Our Ref: PSM5665-091L Rev1

RE: MCCRAE LANDSLIDE - RESPONSE TO SMEC SUBMISSIONS

This letter presents my opinion regarding the following documents with respect to the Board of Inquiry into the McCrae Landslides:

Inset 2: Table 10 of SMEC Causation Report . PSM annotations in red.

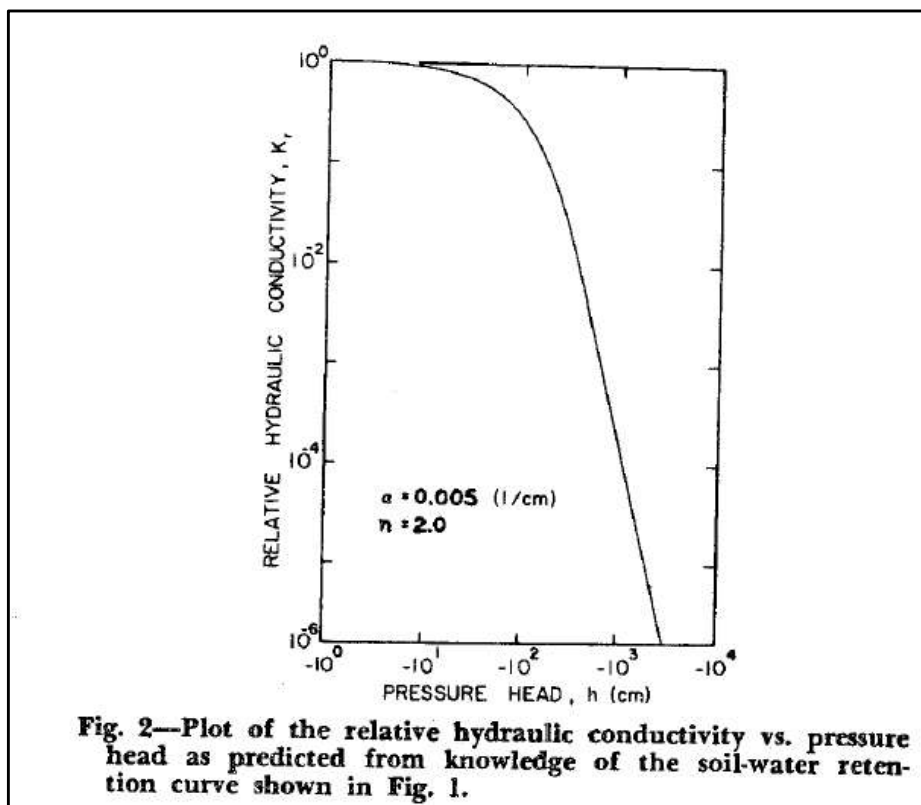
Inset 2 presents a summary of “Permeameter Testing” presented in the SMEC Permeability Testing documents. I have annotated in red what I have inferred to be the geotechnical unit based on SMEC borehole data where available. I note that it is not clear to me:

- What geotechnical unit is being tested with each test. For example, does the tested material comprise RESIDUAL SOIL, COLLUVIUM, FILL etc.
- How SMEC make allowances for unsaturated soil behaviour (i.e. matric suction) external to the testing location (e.g. from established vegetated areas such as the Bayview Road reserve). I would expect the measured permeability to be affected by the influence of the vegetation in the area, and this can result in reported permeabilities orders of magnitude lower (ref. Van Genuchten, 1980), Inset 3.

- How SMEC make allowances for structure in the near surface soils. For example, desiccation cracking. Based on first principles engineering, the permeability of the same soil with cracks is fundamentally higher than a homogeneous mass without cracks.

- How SMEC extrapolates these results to apply to the coarser layers within the COLLUVIUM (for example, as observed in PSM borehole NDT13 and the 2025 Landslide headscarp.
